# **PRODUCT CHANGE NOTICE**

**Alternate Manufacturing Site  
for Assembly of the Listed  
Intersil QSOP and SC-70  
Packaged Products**

**Refer to:  
PCN12091**

**Date: December 4, 2012**

### MDP0040

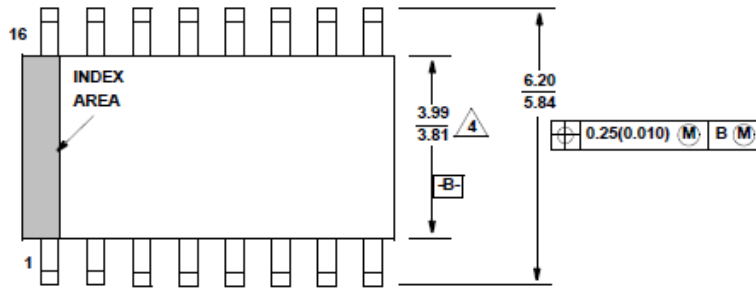
# PCN12091 – Current POD QSOP 16I and 24I

## M16.15A

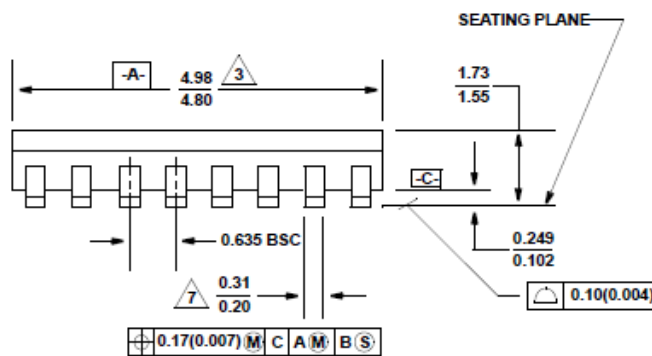
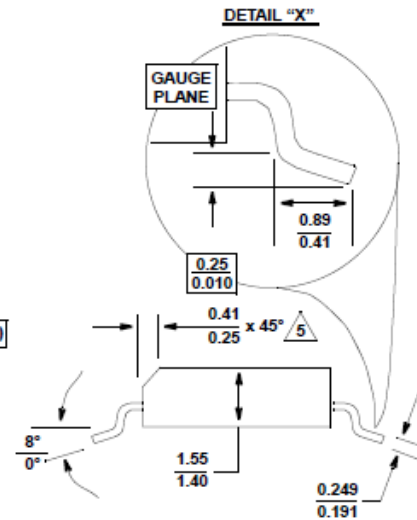
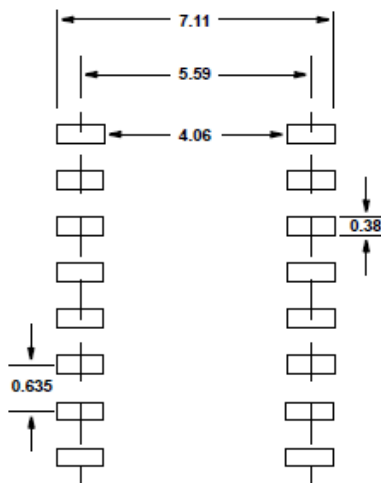
# PCN12091 – New POD QSOP 16I

**M24.15**

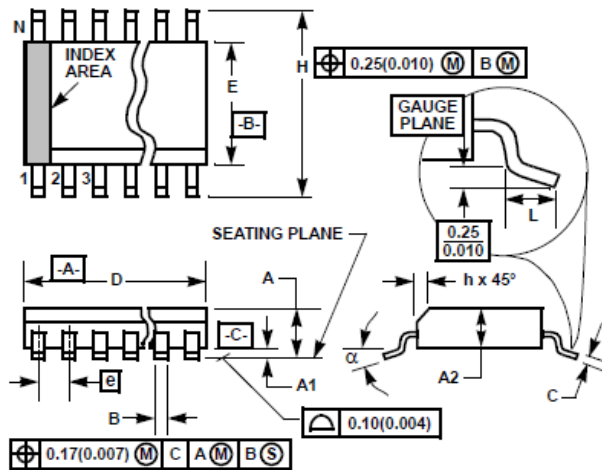
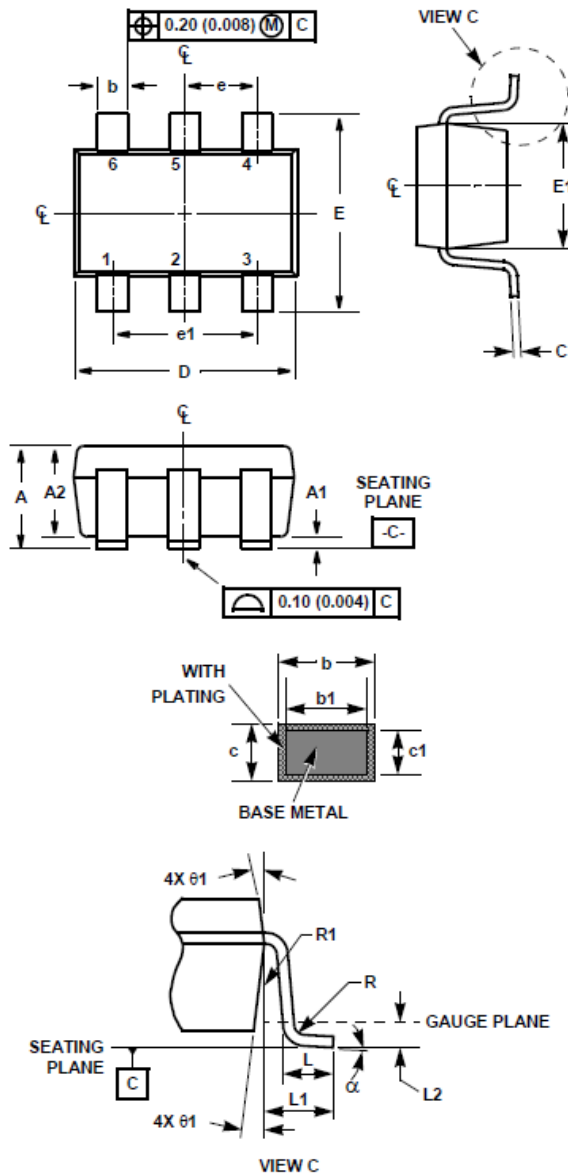
# PCN12091 – New POD QSOP 24I

### P6.049A

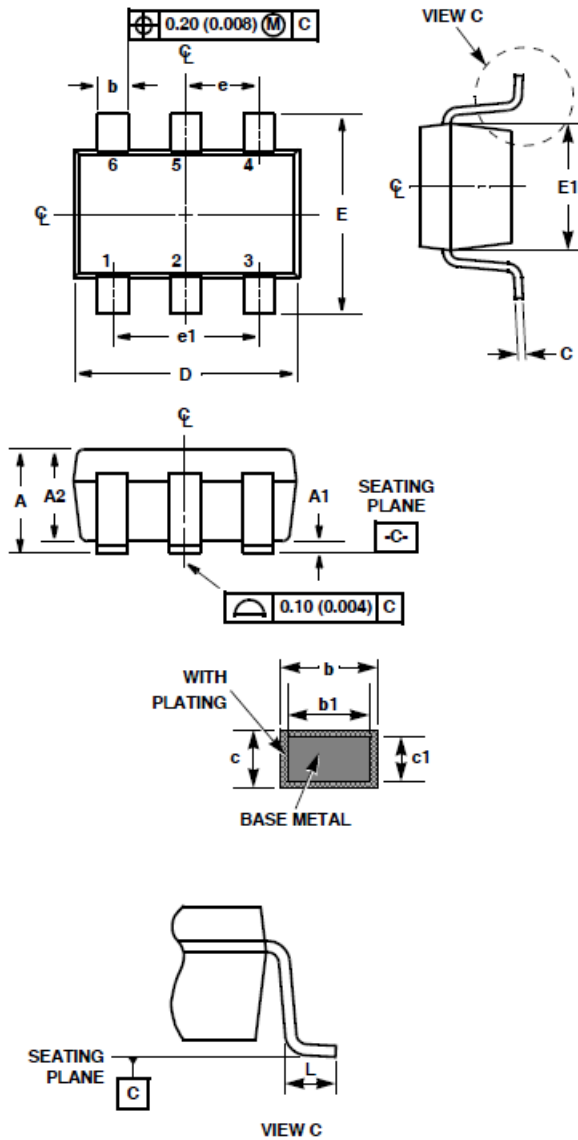
# PCN12091 – Current POD SC-70 6I

### P6.049B

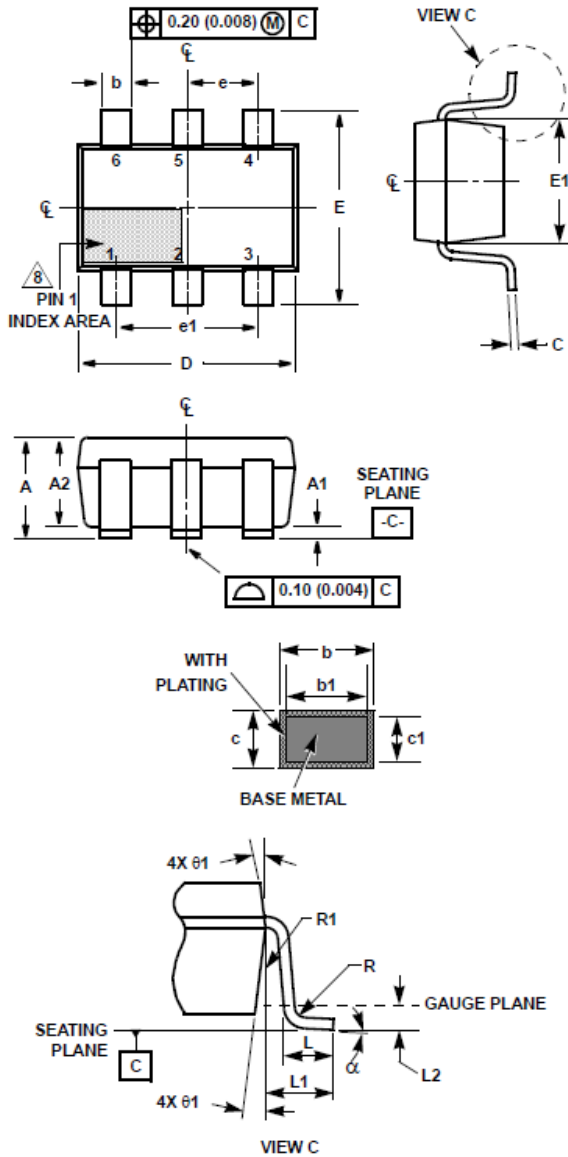
# PCN12091 – Current POD SC-70 6I
